UNITED STATES PATENT AND TRADEMARK OFFICE

APPLICATION NO.	FILING DATE	FIRST NAMED INVENTOR	ATTORNEY DOCKET NO.	CONFIRMATION NO.
10/661,564	09/15/2003	Kyoichi Suguro	03180.0333	8012
22852	7590	03/06/2006	EXAMINER	
FINNEGAN, HENDERSON, FARABOW, GARRETT & DUNNER LLP 901 NEW YORK AVENUE, NW WASHINGTON, DC 20001-4413			COLEMAN, WILLIAM D	
			ART UNIT	PAPER NUMBER
			2823

Office Action Summary	Application No.	Applicant(s)
	10/661,564	SUGURO ET AL.
	Examiner	Art Unit
	W. David Coleman	2823

DETAILED ACTION

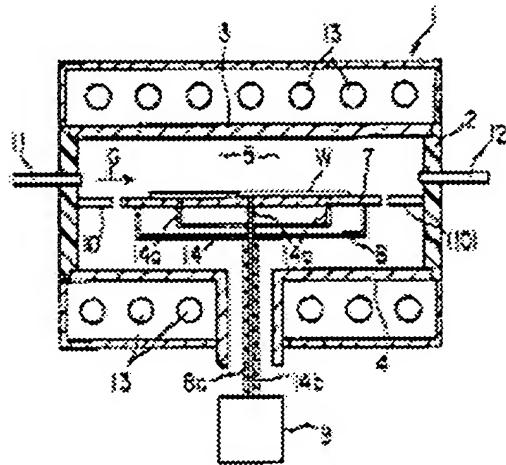
4. Pertaining to claim 1, Suzuki teaches an annealing furnace, comprising:
 - a processing chamber 1 configured to store a substrate W;
 - a susceptor 7 located in the processing chamber so as to load the substrate and having an auxiliary heater for heating the substrate at 650 °C or less [0017], the susceptor having a surface being made of quartz;

- a gas supply system (not shown) having a variety of gas sources (provided in Timans at paragraphs 0163, 0165 and 0167) required for a thermal processing on the substrate in parallel to a surface of the substrate;

- an introduction conduit 11 connected to the gas supply system configured to supply the gas in parallel to the surface of the substrate;
 - an exhaust conduit 12 facing the introduction conduit configured to exhaust the gas from the processing chamber;

- a protective member made of quartz configured to prevent oxidation or corrosion on side and bottom inner walls in the processing chamber

a transparent window located on an upper part of the processing chamber facing the susceptor; and a main heater 13 configured to irradiate a pulsed light (column 1, lines 18-20) on the surface of the substrate to heat the substrate from the transparent window. However, Suzuki fails to teach the pulsed light having a pulse duration of approximately 0.1 ms to 200 ms.

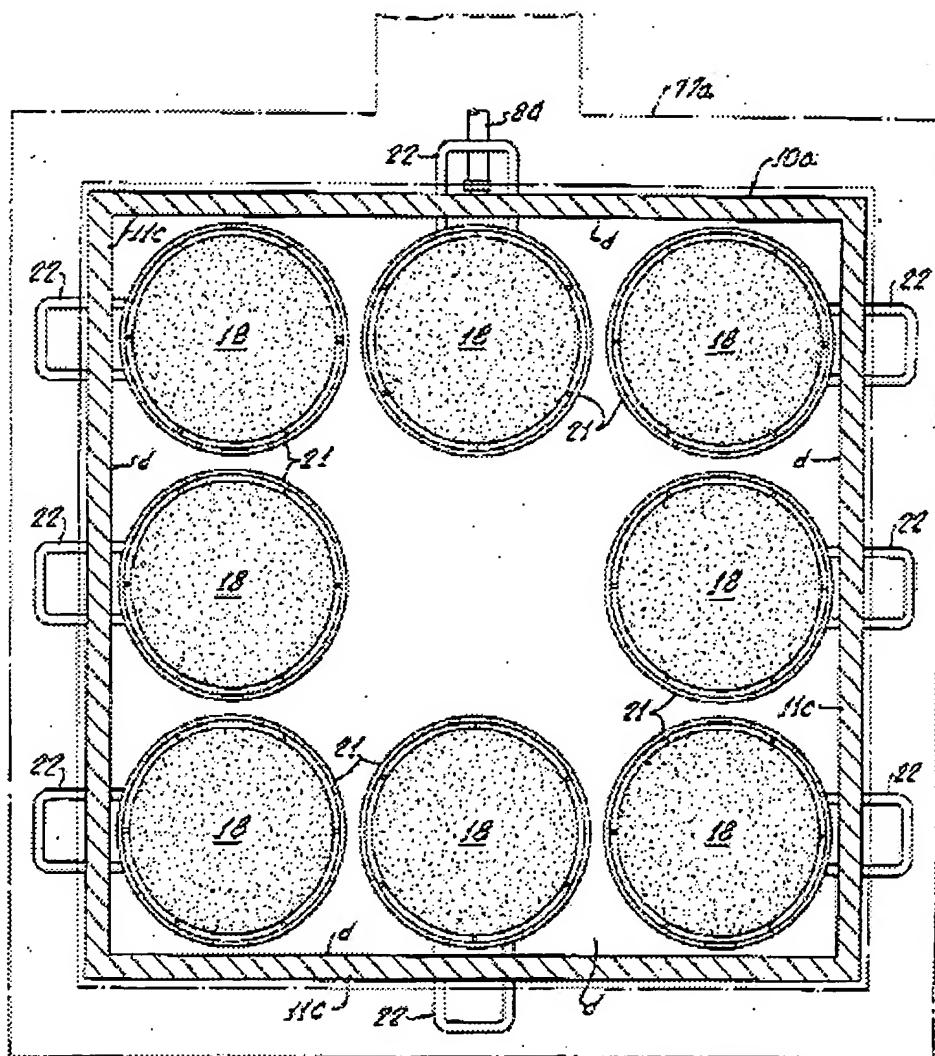
Timans teaches a pulsed light having a pulse duration of approximately 0.1 ms to 200ms. (column 4, line 4, which is within the claimed range) and having a plurality of emission wavelengths (i.e., spectrum, column 3, line 62) and the gas sources including one of a reduction gas and a gas containing halogen for removing a native oxide film formed on the substrate.

Timans also teaches the gas sources including one of a reduction gas and a gas containing halogen for removing a native oxide film formed on the substrate (see paragraph [0169] for surface preparation of a wafer, it is well known that halogen bearing species will remove a native oxide and/or clean the surface of the wafer) In view of Timans, it would have been obvious to one of ordinary skill in the art to incorporate the features of Timans into the Suzuki semiconductor annealing furnace because heat is applied in a controllable way (see Abstract).

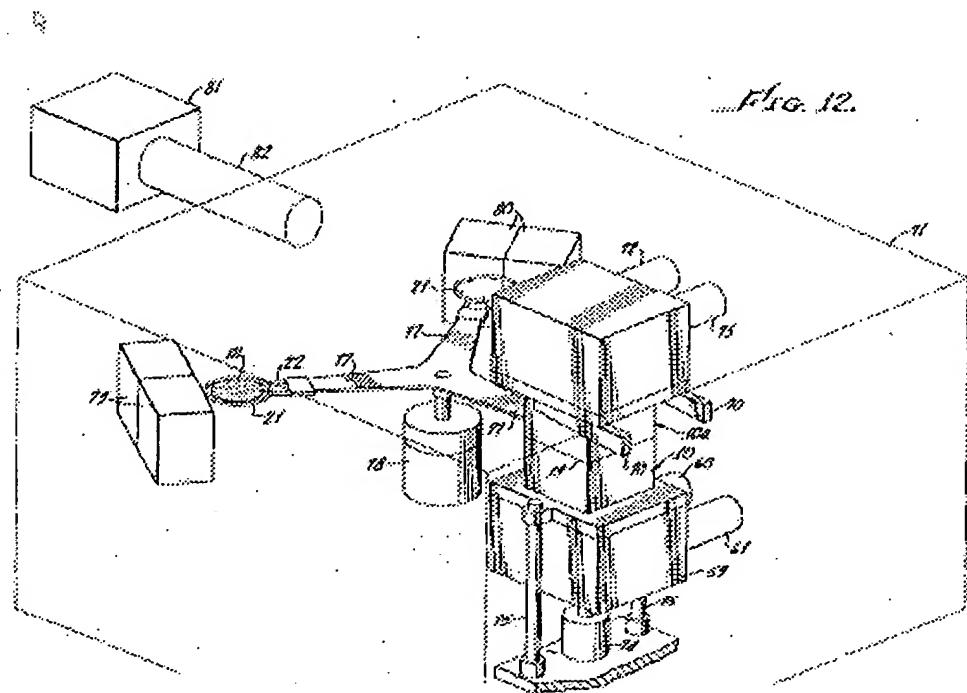
a first cassette chamber to place a wafer cassette for storing a substrate;
a transfer chamber connected to the first cassette chamber, having a transfer robot for transferring the substrate;
a first processing apparatus having a first processing chamber connected to the transfer chamber and configured to store the substrate, a first susceptor located in the first processing chamber so as to load the substrate transferred by the transfer robot, a first introduction conduit supplying a first gas in parallel to a surface of the substrate, the first gas including one of a reduction gas and a gas including halogen for removing a native oxide film formed on the substrate, a first exhaust conduit facing the introduction conduit so as to exhaust the first gas from the processing chamber, a protective member made of quartz configured to prevent oxidation or corrosion on side and bottom inner walls in the first processing chamber, a first

transparent window located on an upper part of the first processing chamber, and a first main heater irradiating a pulsed light on the surface of the substrate to heat the substrate from the first transparent window. Timans the pulsed light having a duration of approximately 0.1 ms to 200 ms and having a plurality of emission wavelengths; and a second cassette chamber to place another wafer cassette storing the substrate transferred from the first processing apparatus by the transfer robot (see FIG. 12 of Sheets).
